Author's Response To Reviewers

Title: Seismic signature of turbulence during the 2017 Oroville Dam spillway erosion crisis

Manuscript Number: esurf-2017-71

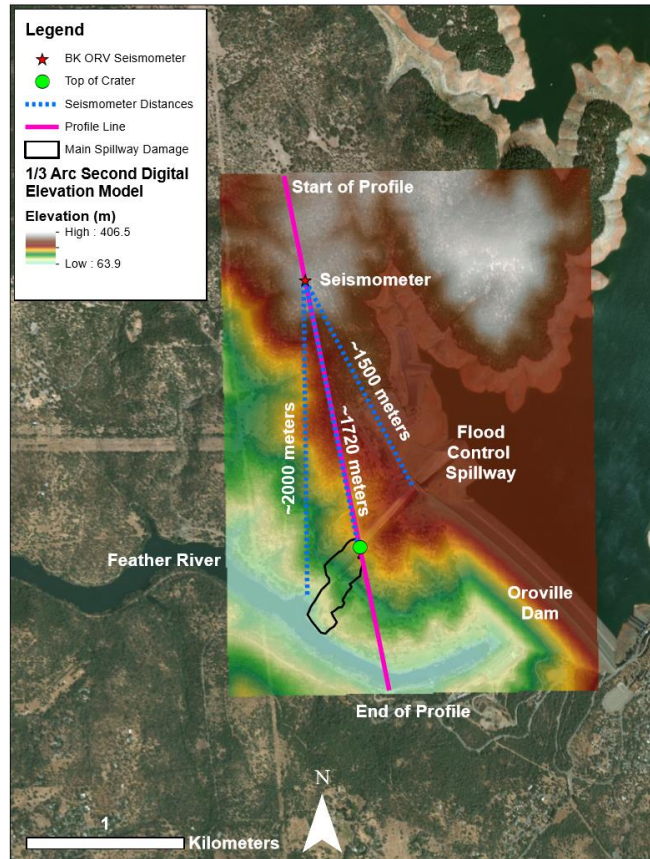
11. Figure 5: It is difficult to tell how much of the differences between 2017 and the other years are just due to the difference in range, and how much of the hysteretic behavior is due to something else. In particular, the low-flow part of 2017 does not appear to have strong hysteresis, and is therefore appears quite similar to the other years, and perhaps not distinguishable if the higher flow segments were not there. Incidentally, the color scale chosen for this figure is poor. Please modify to make the times more distinguishable. Potentially larger symbol sizes are needed, or the black edges could be removed to make clearer.

We have changed the x axis scale in the to the 2006 and 2011 time periods in Figure 5 to make the behavior more visible and have modified the color map, removed the black symbol edge lines, and improved the figure resolution. We agree that no hysteresis is observed in the 2006 and 2011 releases or in the early part of 2017, as stated on P11L4-6. The two releases shown are the largest two available for comparison. For consistency, we changed the color scale, line widths, symbol edge lines, and resolution in Figure 8 as well.

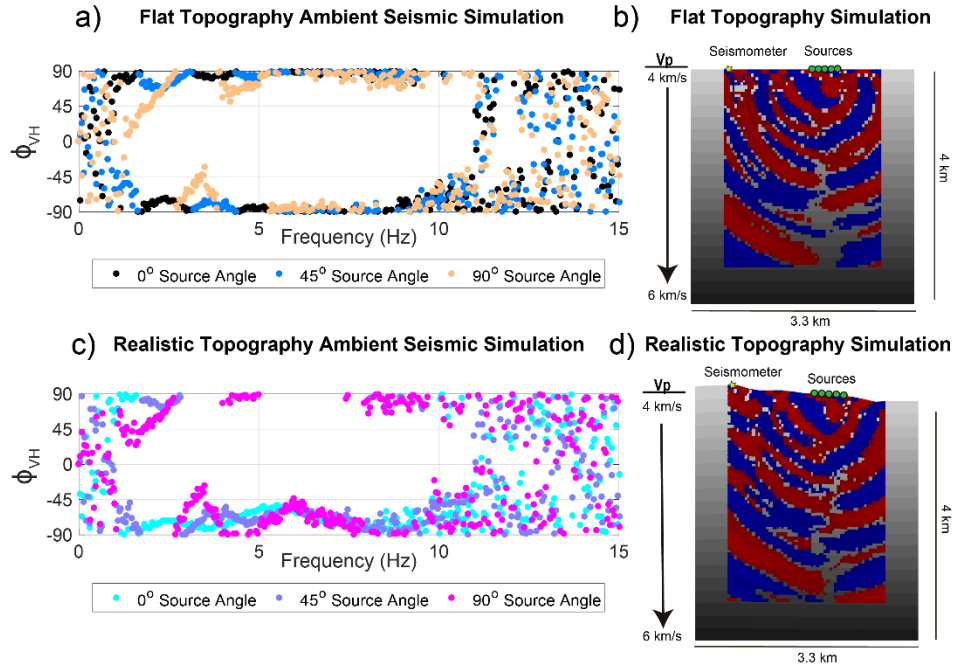
18. P16L26: Do these simulations use uniform velocities? If so, this might yield misleading results, since a more realistic structure in which velocities increase with depth naturally have stronger trapping of waves near the surface, and thus stronger surface waves. (If simulations use non-uniform velocities, that should be clarified as well.) Partly for this reason, it is not clear how much of this section's analysis really explains the deviations discussed.

The simulations as shown in the manuscript used a uniform velocity structure, though we recognize the potential for a velocity structure to influence the results. This comment and comments by Reviewer #2 motivated us to conduct a series of new simulations:

- Introduce a linearly-increasing V_p from 4 km/sec to 6 km/sec while maintaining the Poisson solid assumption.
- Increased the depth of the model domain from 1 km to 4 km to minimize potential effect of domain edges.

- Change the dominant frequencies of the source, which were 0.1 to 5 Hz and represented the largest increase in seismic energy from the spillway as shown in Figure 4. The new dominant source frequencies are between 5 to 10 Hz, which represent the greatest deviations from Rayleigh-like particle motions observed in Figure 7.

- We reduce the simulated time from six minutes to four minutes due to increased computation time due to the larger domain.
- We approximate the source of the seismic energy as along the flood control spillway channel. Due to the position of the spillway channel, the distance between the channel and the station has a range of approximately 500 meters. We simulate the distributed source of the seismic energy as five independently fluctuating point sources along 500 meters of the seismic profile. This simplification ignores the different in hillslope topographies encountered by waves travelling from the top of the spillway and the bottom of the spillway. The below figure is an updated version of Figure S3 in the supplemental materials showing the configuration of the spillway.

- We add random noise to the resulting synthetic seismogram to represent the background seismic energy excited by other sources.

The results of the simulations after making these changes are similar to but much more realistic than those from previous simulations. The simulation with a realistic topography shows a deviation from a Rayleigh-like particle motion of $\pm 90^\circ$ to $\pm 45^\circ$ between 5 and 10 Hz, which is similar to the results presented in Figure 7. The updated Figure 9 showing the simulation results is below.

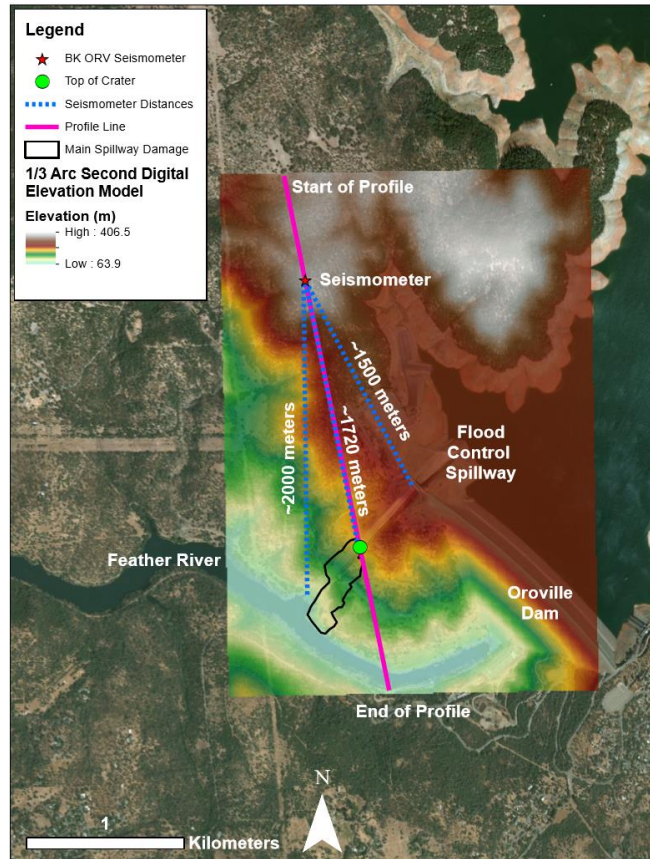
4. *Fig. 7. The authors might consider labeling the azimuth corridor that corresponds to the spillway as a handy visual reference. But I understand that it may not be ideal if it obstructs other information.*

We added dashed lines indicating the azimuth corridor and added the following sentence to the figure 7 caption: “Dashed lines in the first column of figures indicates the azimuth range of the spillway relative to the seismometer (See Fig. 1).”

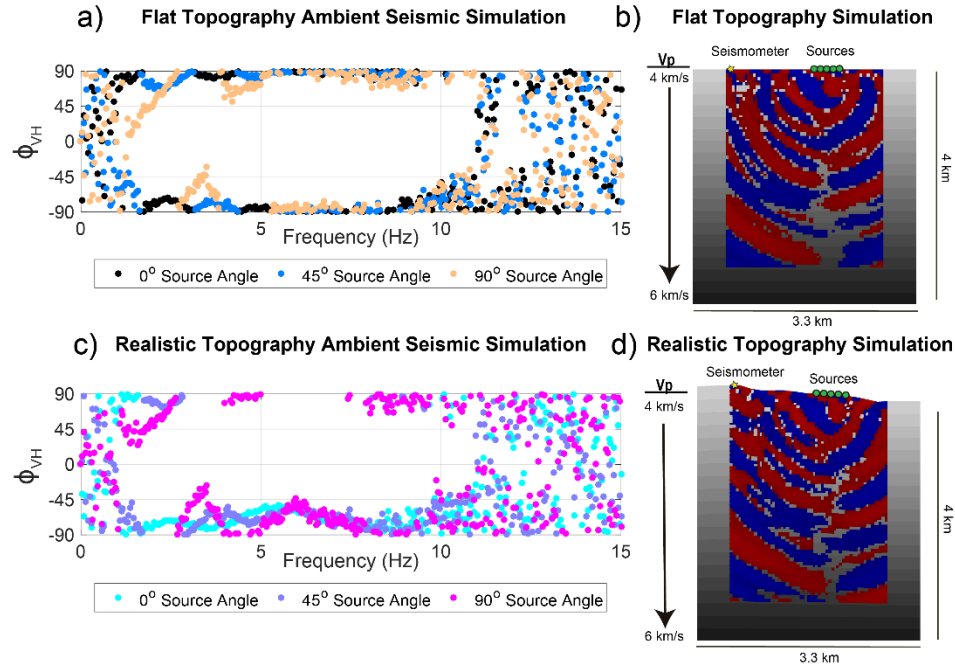
5. *Section 4.7. This is a good attempt at estimating the effect of topography on the polarization results, and the authors acknowledge some of the limitations of the 2D simulation. I would suggest a bit of additional caution regarding the simple velocity model because the frequency dependent polarization of surface waves could be strongly affected by depth-dependent (and spatially variable) velocity structure likely including anisotropy. I agree that the modeling effort presented provides a viable explanation for some*

6. *Section 4.7. and Fig. 9. Is the oscillating VH angle in Figure 9 because only one point source is considered? Would it be more realistic to sum the seismograms with staggered time shifts to simulate a temporally continuous and spatially distributed source process*

The simulations as shown in the manuscript used a uniform velocity structure, though we recognize the potential for a velocity structure to influence the results. This comment and comments by Victor Tsai (Reviewer #1) motivated us to change our simulation in the following ways:

- Introduce a linearly-increasing V_p from 4 km/sec to 6 km/sec while maintaining the Poisson solid assumption.
- Increased the depth of the model domain from 1 km to 4 km to minimize potential effect of domain edges.

- Change the dominant frequencies of the source, which were 0.1 to 5 Hz and represented the largest increase in seismic energy from the spillway as shown in Figure 4. The new dominant source frequencies are between 5 to 10 Hz, which represent the greatest deviations from Rayleigh-like particle motions observed in Figure 7.

- We reduce the simulated time from six minutes to four minutes due to increased computation time due to the larger domain.
- We approximate the source of the seismic energy as along the flood control spillway channel. Due to the position of the spillway channel, the distance between the channel and the station has a range of approximately 500 meters. We simulate the distributed source of the seismic energy as five independently fluctuating point sources along 500 meters of the seismic profile. This simplification ignores the different in hillslope topographies encountered by waves travelling from the top of the spillway and the bottom of the spillway. The below figure is an updated version of Figure S3 in the supplemental materials showing the configuration of the spillway.

- We add random noise to the resulting synthetic seismogram to represent the background seismic energy excited by other sources.

The results of the simulations after making these changes are similar to but much more realistic than those from previous simulations. The simulation with a realistic topography shows a deviation from a Rayleigh-like particle motion of $\pm 90^\circ$ to $\pm 45^\circ$ between 5 and 10 Hz, which is similar to the results presented in Figure 7. The updated Figure 9 showing the simulation results is below.

Thank you very much for this helpful suggestion! As you suggest, we now approximate a distributed source by five point sources that independently fluctuate with a dominant source frequency of 5-10 Hz. We also add in a low level of random noise to resulting synthetic seismograms to approximate background seismic noise. The oscillating VH angle behavior is diminished from both of these steps, and we believe the VH angle behavior is more realistic.
